ARAPAHO ROAD PHASE III
 PLAN & PROFILE
STORM SEWER LINE 'A' STA. -1+84.79 TO STA. 0+85.21

TOWN OF ADDISON

G&A Grantham & Associates, Inc. SHT. SW-1

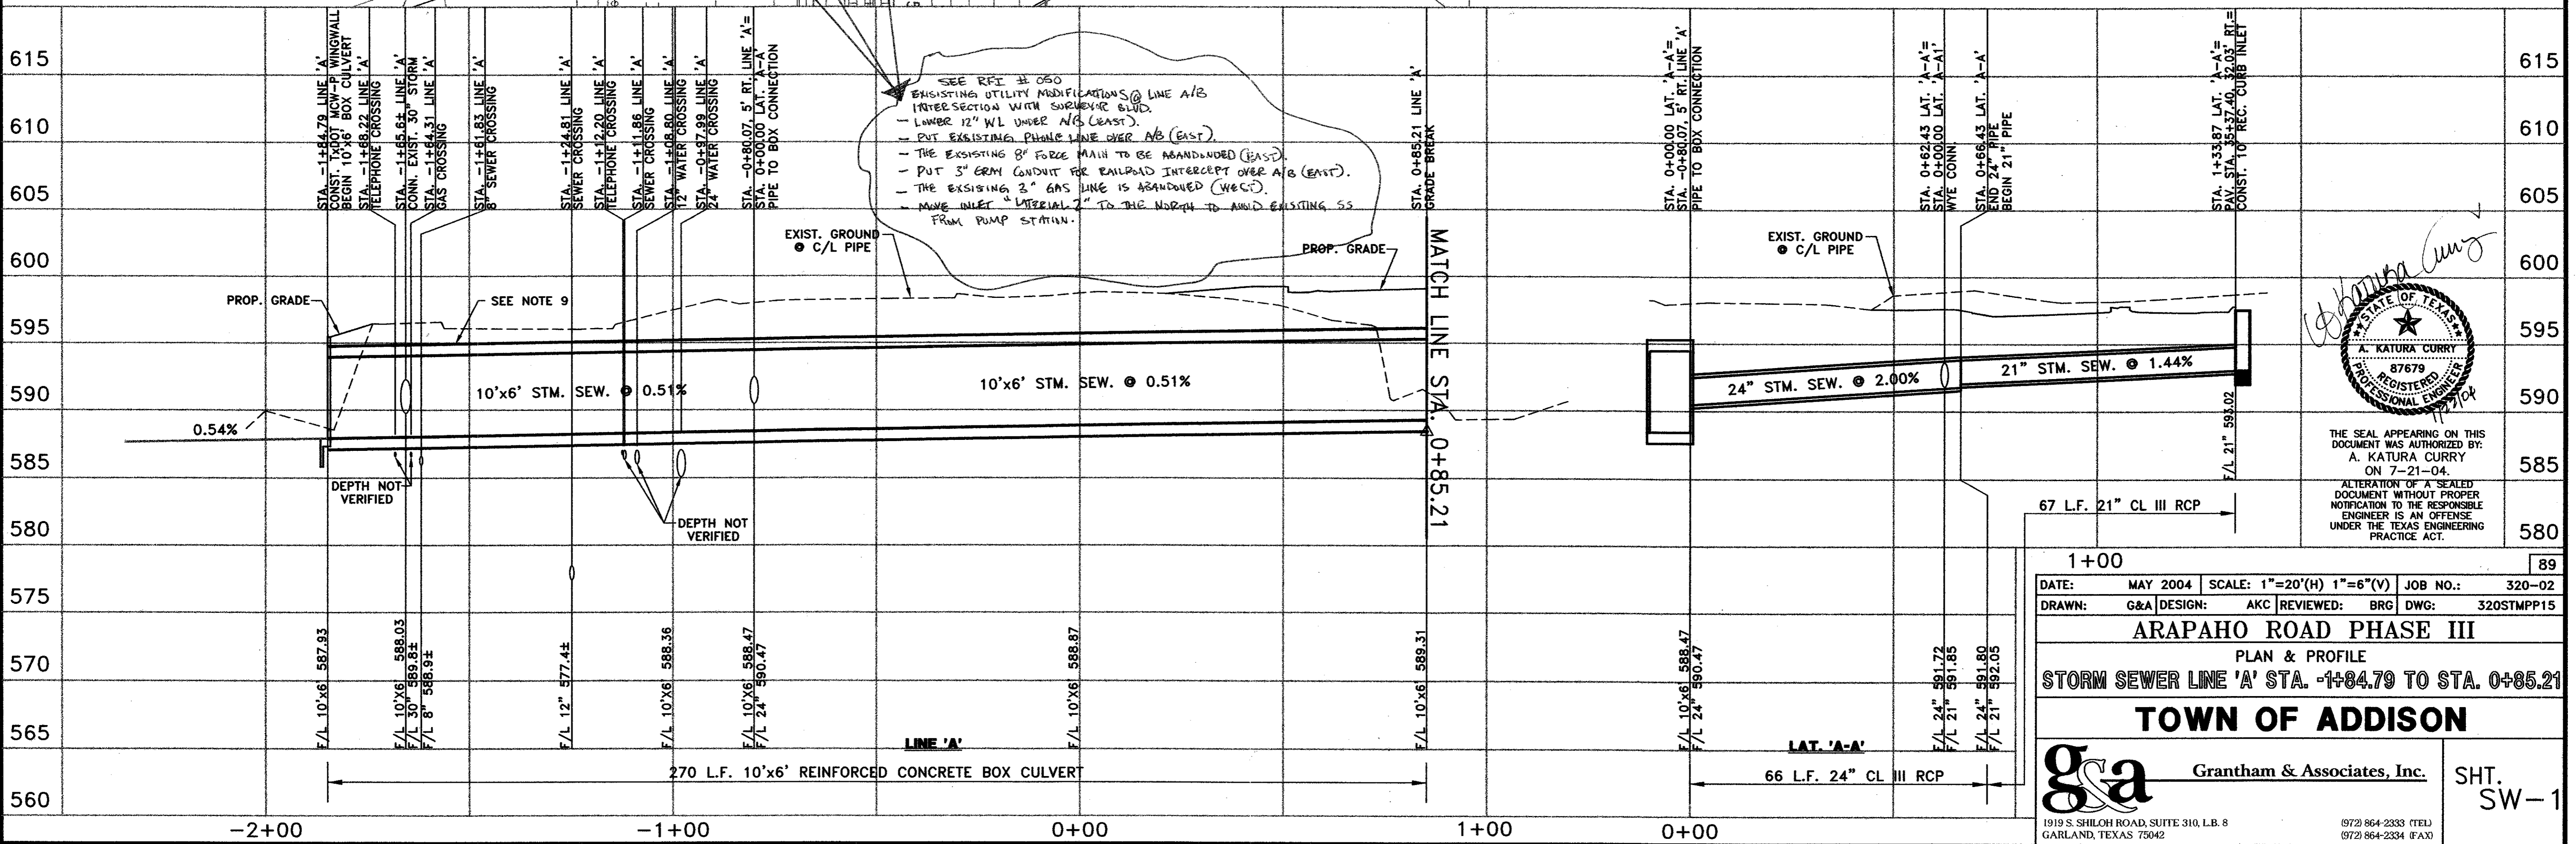
Conduit #7 As Built

Loc	STA	9/5	Top Conduit Elev
①	35182.14	60.8544	595.66
②	35191.42	54.6244	595.72
③	35193.20	53.7244	585.13
④	36151.79	54.1244	580.38
⑤	36161.63	54.1844	596.22

SEE RFI # 027 (SEE SHEET # 21a)
GRADED PIPE DETAIL
